Amendments to the Drawings:

Remarks/Arguments:

Fig. 1

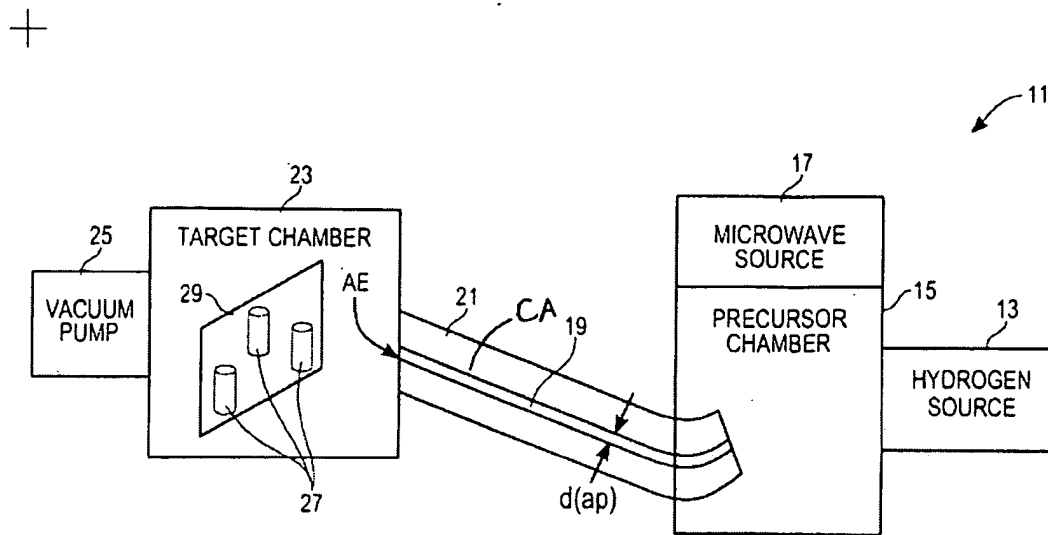
The Examiner objects to certain inconsistencies between the specification and the drawings, noting that the reference numeral 25, CA, 11", 21" and PS are present in the drawings but are not defined in the specification, and that reference numerals CA', CA" and 86 are mentioned in the specification but are not shown in the drawings.

The reference number 25 in Figures 1, 6 and 7 refers to a vacuum pump for a target chamber 23. The reference numeral CA which should, but does not, appear in Figure 1, refers to a central axis of an aperture or channel 19 between a precursor chamber 15 and a target chamber 23 and is discussed at page 6, line 17. The reference numeral 11', shown in Figure 6, refers to the system or apparatus shown in Figure 6. The reference numeral 11", shown in Figure 7, refers to the system or apparatus shown in Figure 7. The reference PS, shown in Figure 8, refers to a production site in a precursor chamber 85 and is discussed at page 10, line 23, and at page 11, line 5. A proposed amendment to Figure 1 is presented that adds reference numeral CA. The specification is amended at page 4, line 5, and at page 8, lines 17 and 28. The Applicants believe that, with these proposed amendments implemented, the inconsistencies between drawings and specifications are resolved.

Proposed amendment shown in red

Fig. 8

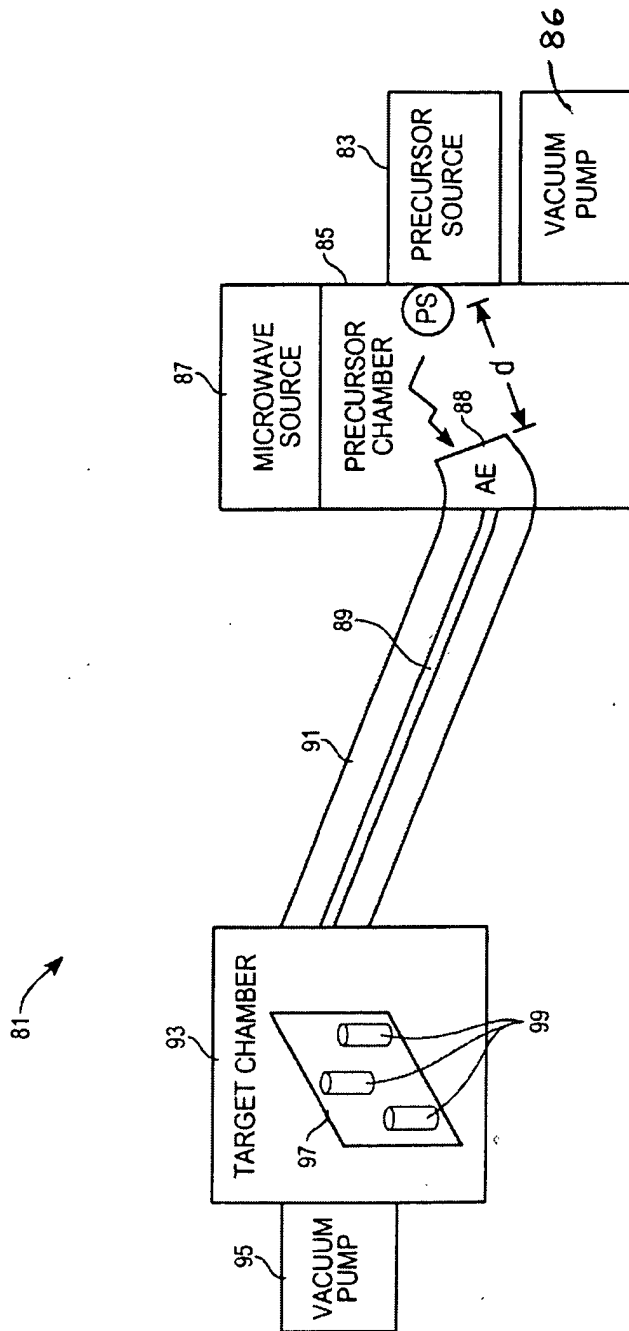
Proposed amendments to Figures 6, 7 and 8 are presented here to change CA to CA' (Figure 6), change CA to CA" (Figure 7), and add reference numeral 86 to Figure 8.

Proposed amendment shown in red
